# Engineering Policy Ballot

Effective: October 1, 2026

# ENGINEERING POLICY BALLOT

## **Issue 1: Incorporating Balanced Mix Design (BMD) Into Sec 403**

DRIVEWAY TYPICAL SECTION

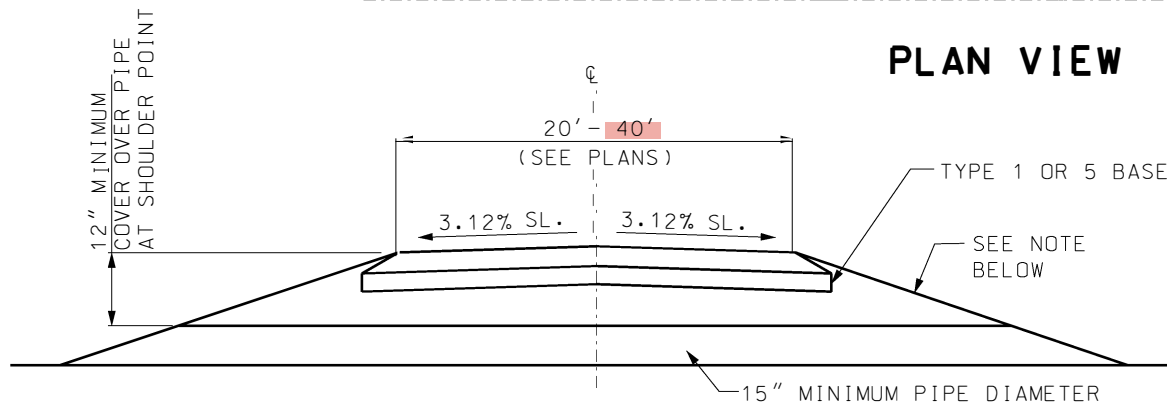
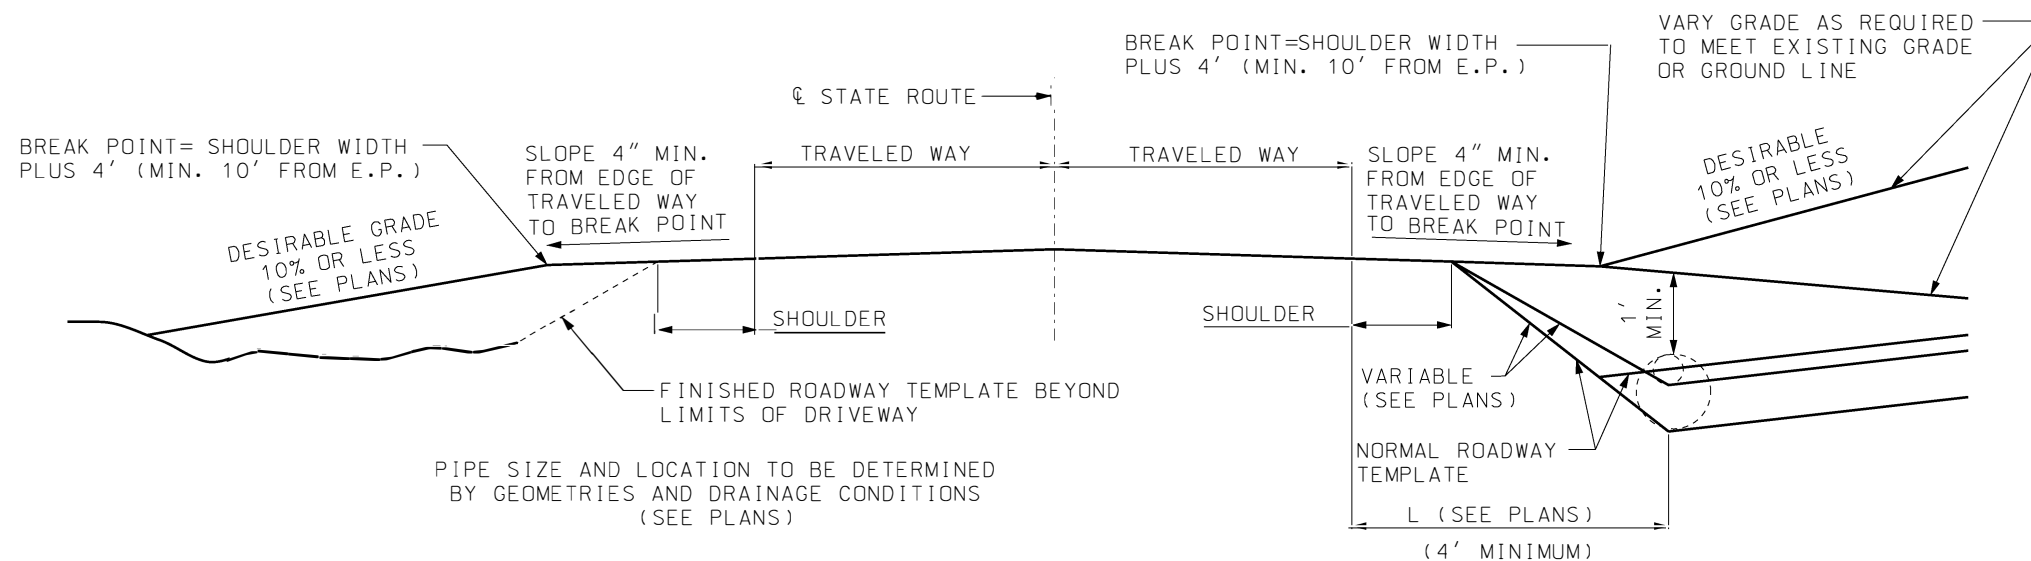
## **Issue 6: Driveway Type I Requirement Modifications**

**Publication:** Missouri Standard Plans: 203.61  
Engineering Policy Guide: 940.16

DATE EFFECTIVE: 10/1/2026	<b>502.06</b>	SHEET NO. 1 OF 2
DATE PREPARED: 3/3/2026

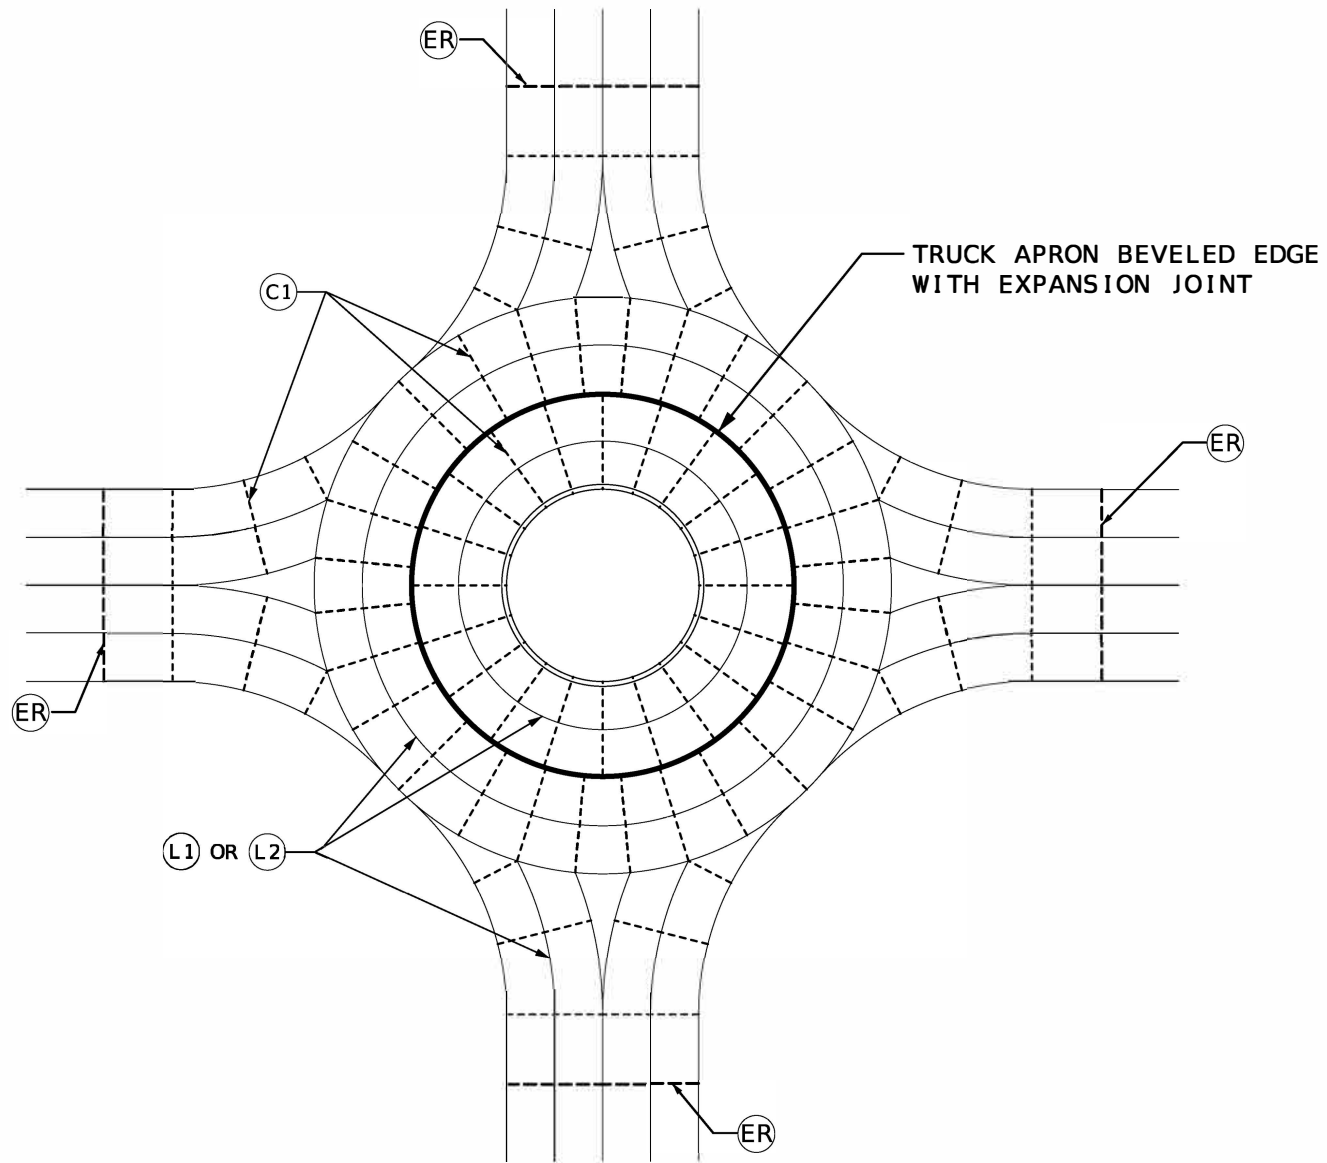
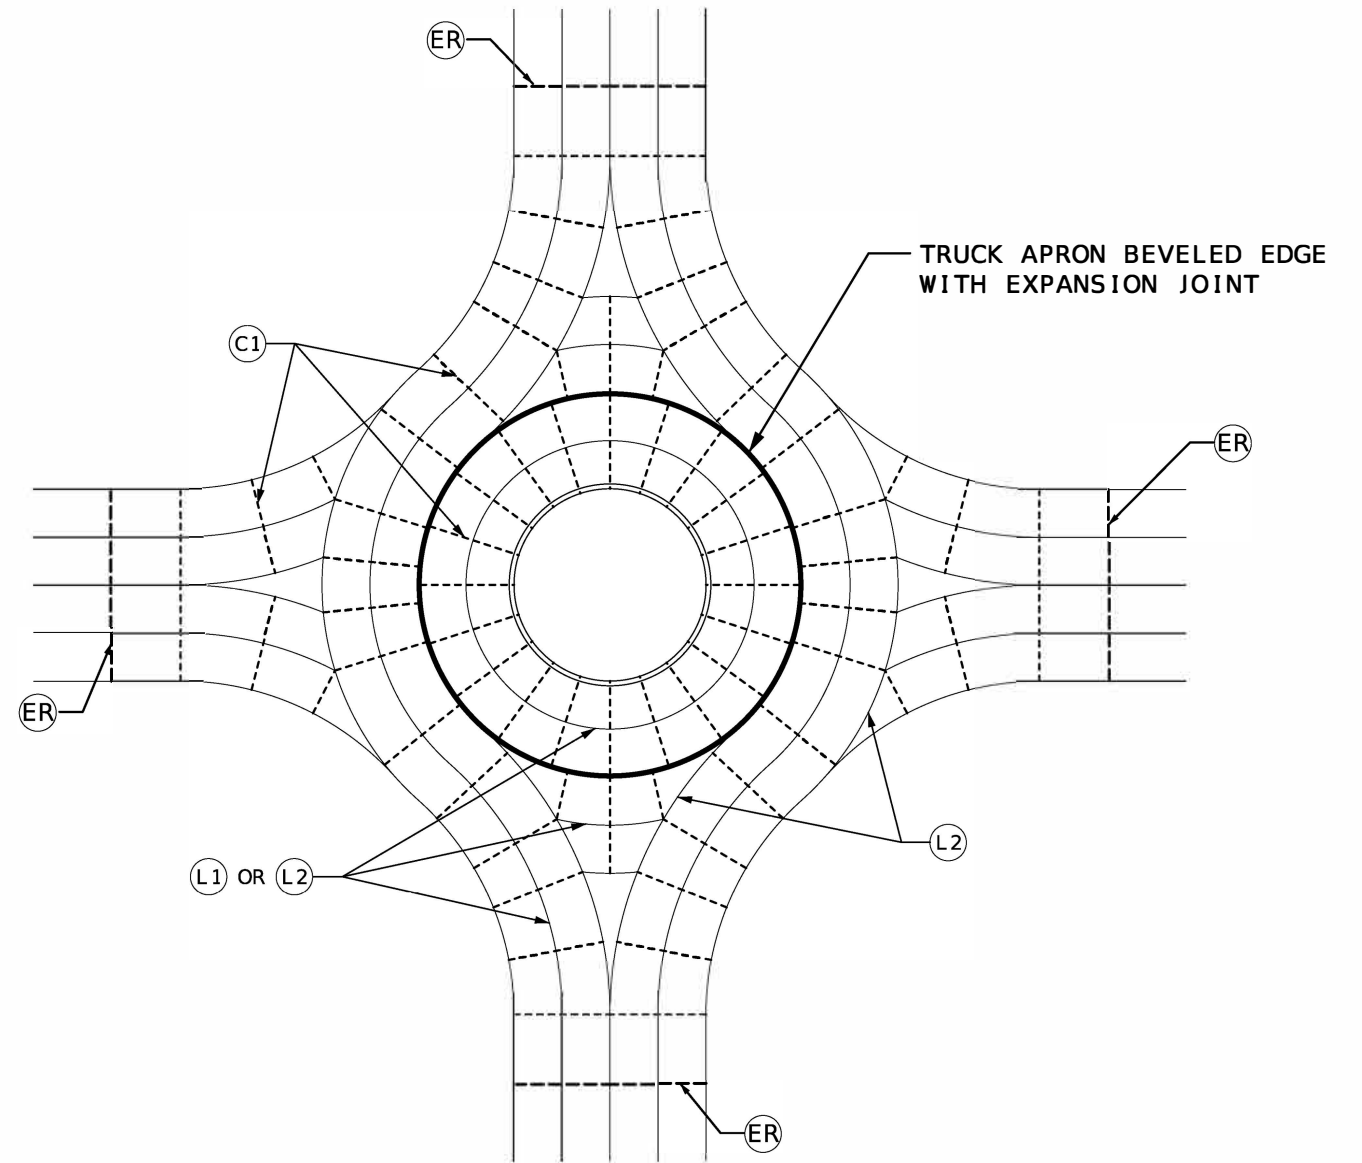
**Summary:** New standard plan for concrete roundabouts to serve as starting point of joint layout.

**Publication:** Missouri Standard Plans: 502.06

Figure 1. Process for determining alkali carbonate reactivity for new ledges and quarries.

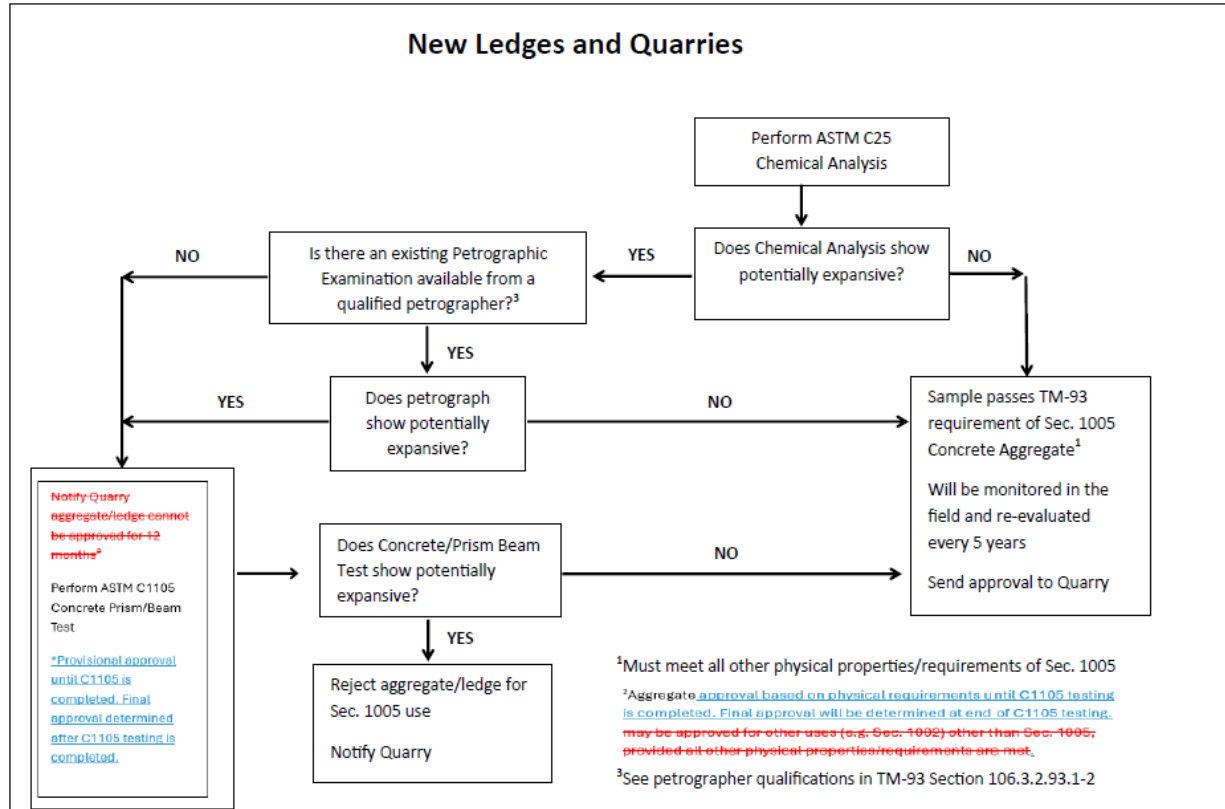
**Summary:** Updated EPG charts to show current process of approving concrete aggregate. The change allows for provisional approval based on physical test results until the 12 month C1105 is complete and removes the 6 and 9 month limits for C1105 in accordance with the revised ASTM C1105 specification.

**Figure 131.1.4.1. Roadway Design Exception Process**

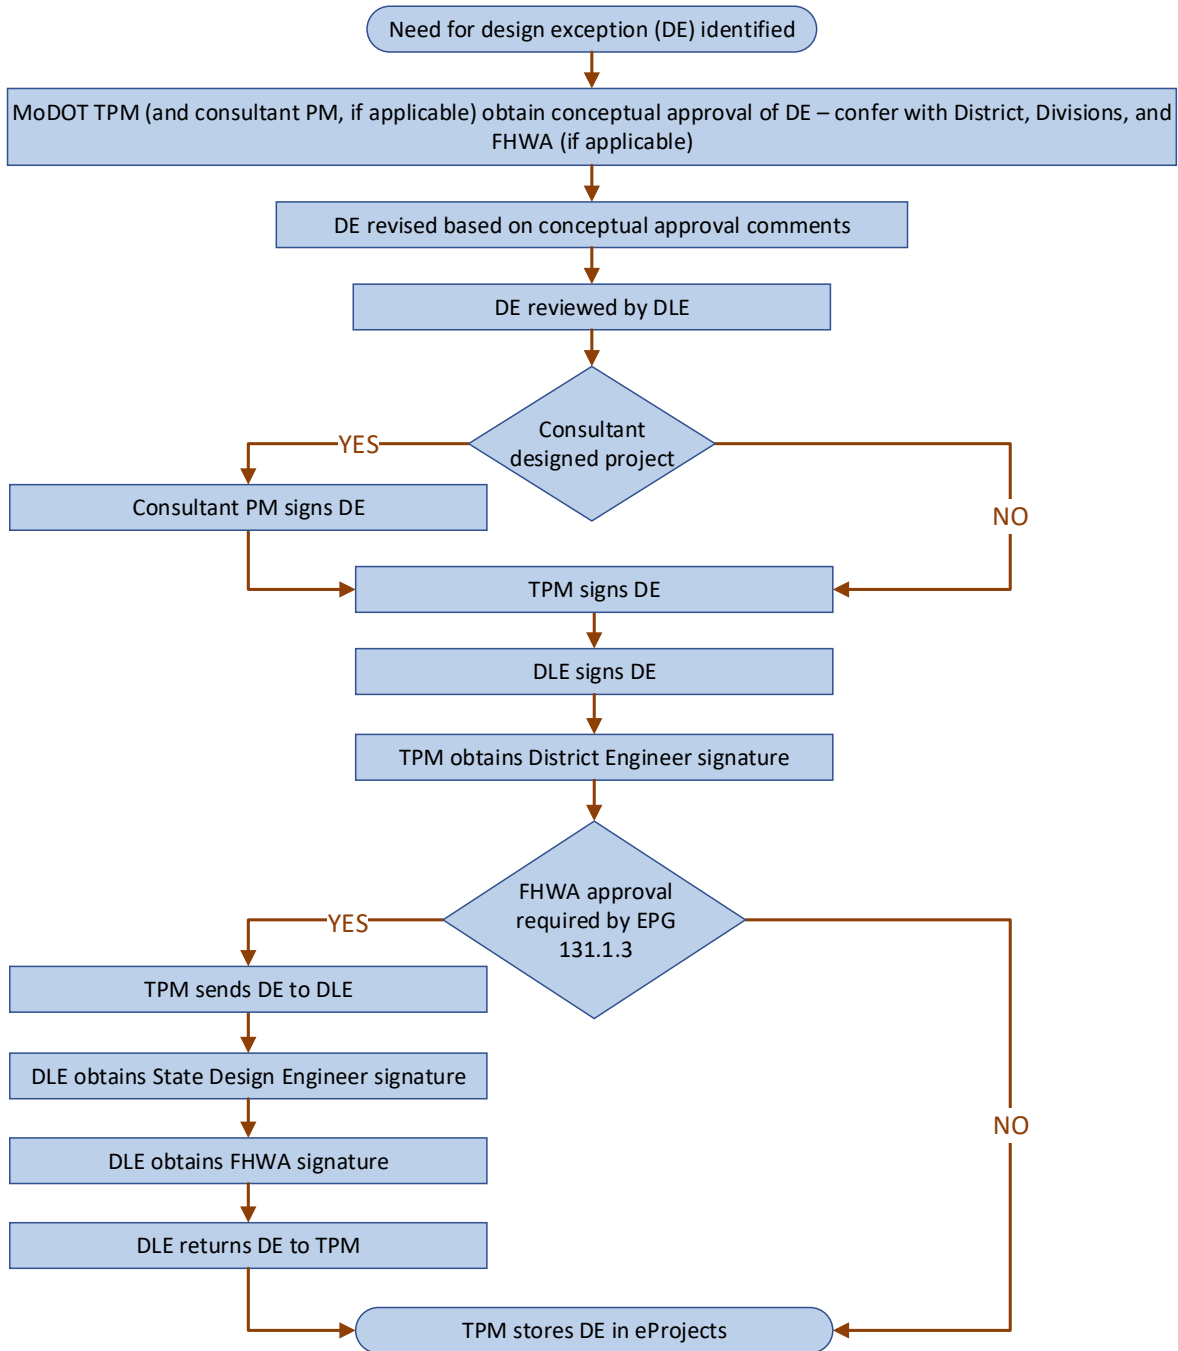
~~\* Note: Concurrence only if not indicated that federal approval is required in accordance with EPG 131.1.3 and the PODI matrix.~~

~~\*\* Note: Omitted if not indicated that federal approval is required in accordance with EPG 131.1.3 and the PODI matrix.~~

**Figure 134.1.4.2.** Bridge Design Exception Process

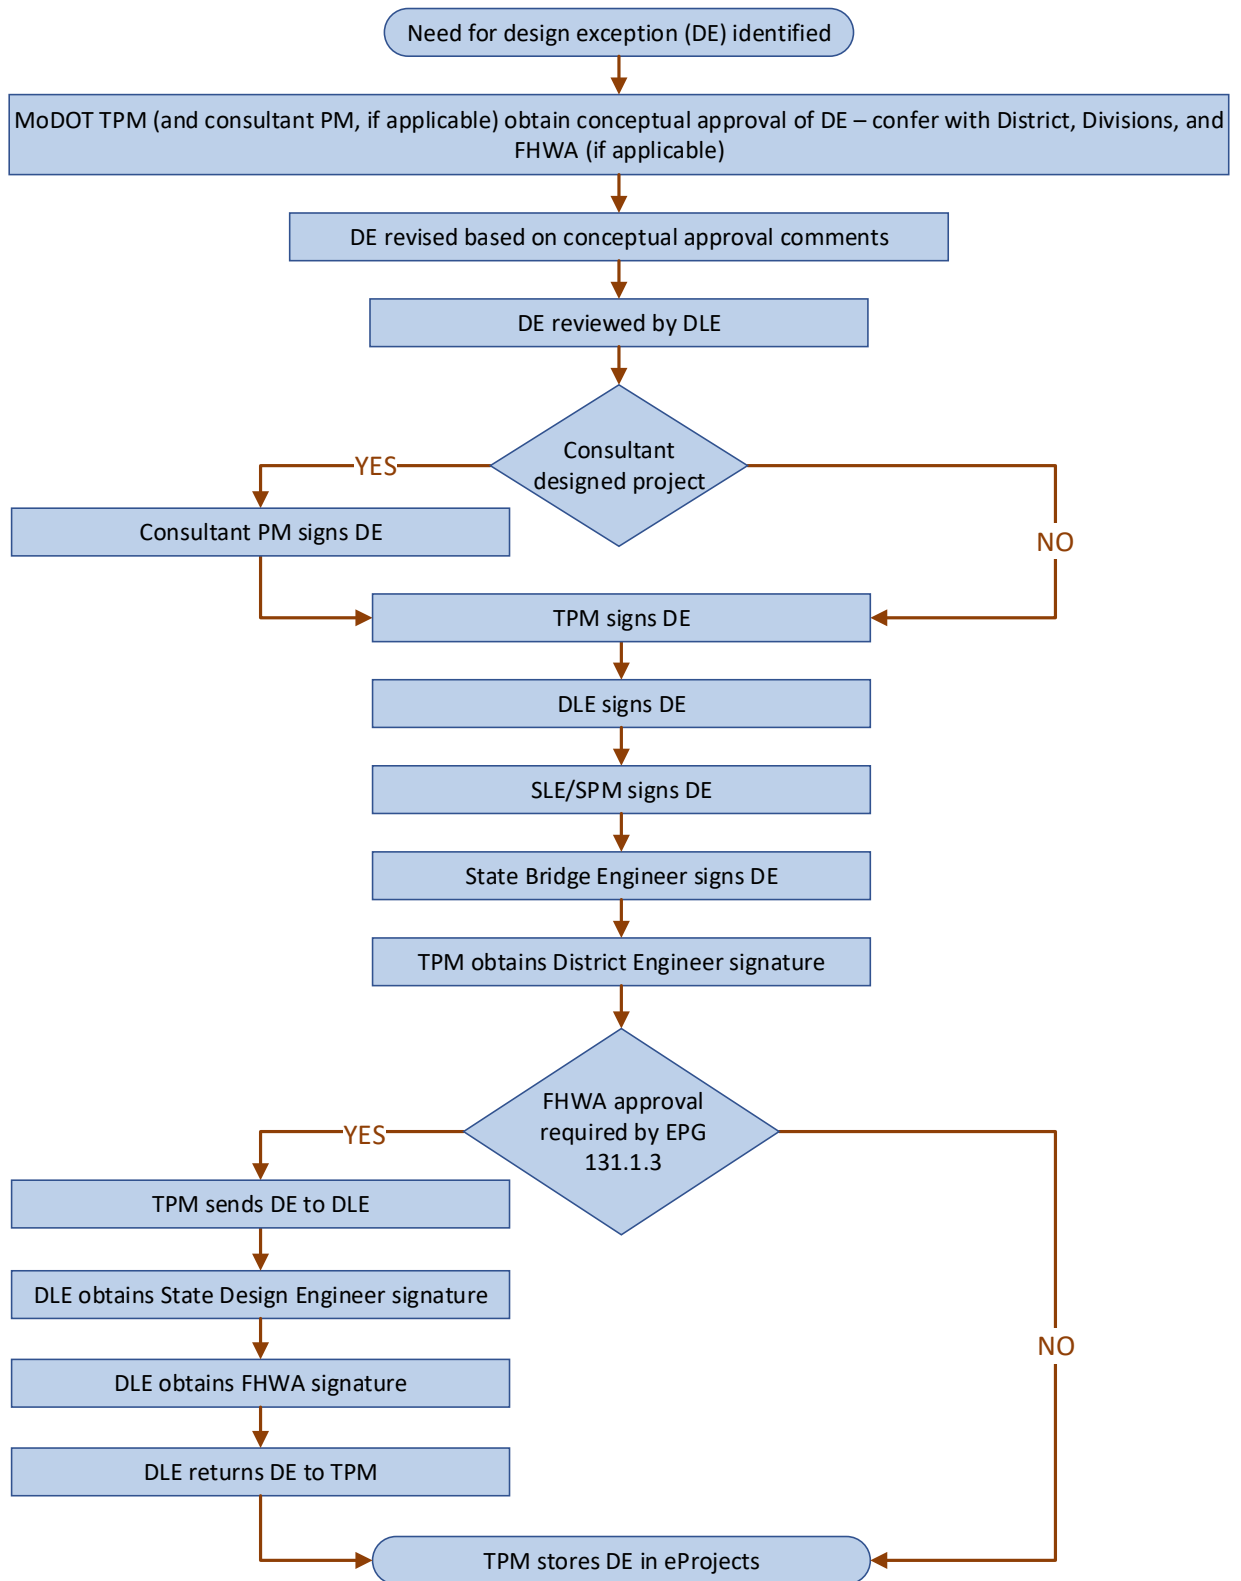
~~\* Note: Concurrence only if not indicated that federal approval is required in accordance with EPG 131.1.3 and the PODI matrix.~~

~~\*\* Note: Omitted if not indicated that federal approval is required in accordance with EPG 131.1.3 and the PODI matrix.~~
